Field Service Bulletin Trucks

This FSB replaces Field Service Bulletin "PV729–FSB431–003_M, Revised Range Clutch Synchronizer Components", (USA53636) dated (5.2012).

Revised Range Clutch Synchronizer Components T200, T300 CHU, CXU, GU, TD, CHP, CTP, CX, CH, CXN, CHN, CL, CV, CT, MR, DM, RD

FSB 431-003, Range Clutch Synchronizer Components

Clutch Teeth with Dove-tail Cut

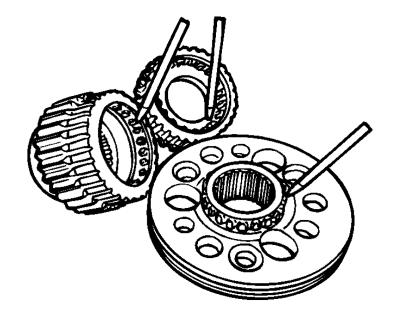
The T200/T300 range synchronizer clutch material and tooth design have been changed to improve durability and resist disengagement. A more robust material is now used. Also there is an increase in the dove-tail cut of the clutching teeth in both the synchronizer clutch and mating hi range gear and lo range hub. The new range synchronizer clutch and mating gears were incorporated into production on 05/23/2011, beginning with transmission serial number 3772. The part number for the new range synchronizer clutch is 21636360.

Because of the increase in the dove-tail cut of the clutch teeth between the previous style range clutch and the current production range clutch, the range clutch, the mating high gear and the low gear hubs must be replaced as a set. If any one of the three previous style components is damaged, or when converting from the previous style to the new style range clutch/synchronizer, all three items must be replaced with the current components. For replacement information for these components refer to the appropriate transmission model's service manual or Service Manual "In-Chassis Synchronizer Removal Manual", 10–701.
